Monticello Nuclear Power Station License Renewal Project

Response to NRC Question Regarding N2 Nozzle USE Information

Supplemental Information Related to Previous RAIs Responded to on December 7, 2005

Correction of Errors in Describing and Referencing Requirements of the American Society of Mechanical Engineers (ASME) Section XI Inservice Inspection and Testing Program for Purposes of License Renewal

Figure 1 Forgings Meet Equivalent Margin Requirements

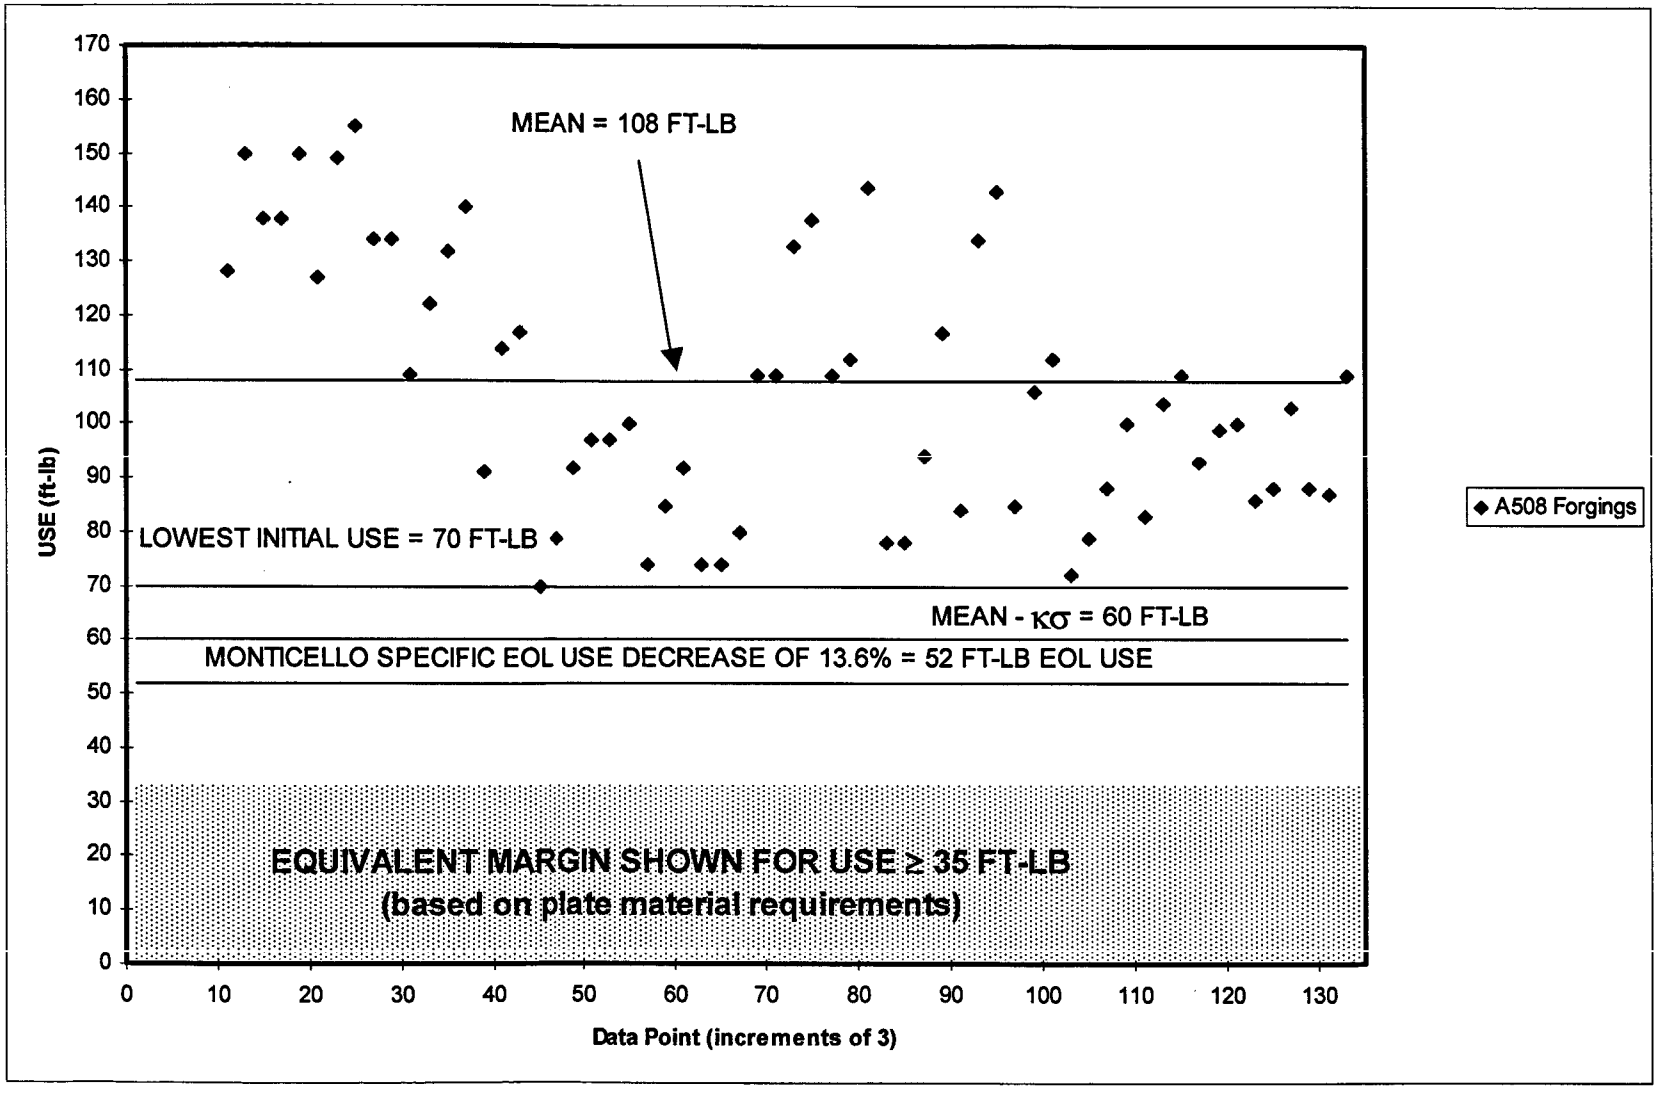
1. **NRC RAI 4.2-3b**

In its initial response to RAI 4.2-3, dated October 28, 2005, the applicant provided a table projecting Upper Shelf Energy (USE) data through the period of extended operation. The staff noted the table was missing data for the nozzles. The applicant referenced BWRVIP-74, which provided USE data for the plates. However, the staff noted that nozzles are forged components, not plates, and requested the applicant to provide a technical basis for their position that the plates are limiting components.

To further demonstrate the acceptability of the N2 nozzle fracture toughness, forging data determined from RVID2 is applied specifically to MNGP. Figure 1 provides the forging data from RVID2 in a manner similar to Figure B-4 of Reference 5. Using Revision 2 of Regulatory Guide 1.99 (RG 1.99) in conjunction with the RVID2 forging database results, the MNGP-specific forging end-of-life (EOL) USE becomes:

MNGP 54 EFPY N2 Fluence	5.23e17 n/cm^2
MNGP N2 %Cu	0.18 (bounds worst case in RVID2 = 0.17)
RG 1.99 Predicted %Decrease	13.6 (using Figure 2 of RG 1.99)
(Mean – $\kappa\sigma$) * (1 - %Decrease/100)	[108 – (1.9996 * 24)] * [1 – 13.6/100)]
EOL USE	52 ft-lb

The EOL USE of 52 ft-lb exceeds the transverse plate requirement of 35 ft-lb for equivalent margin.
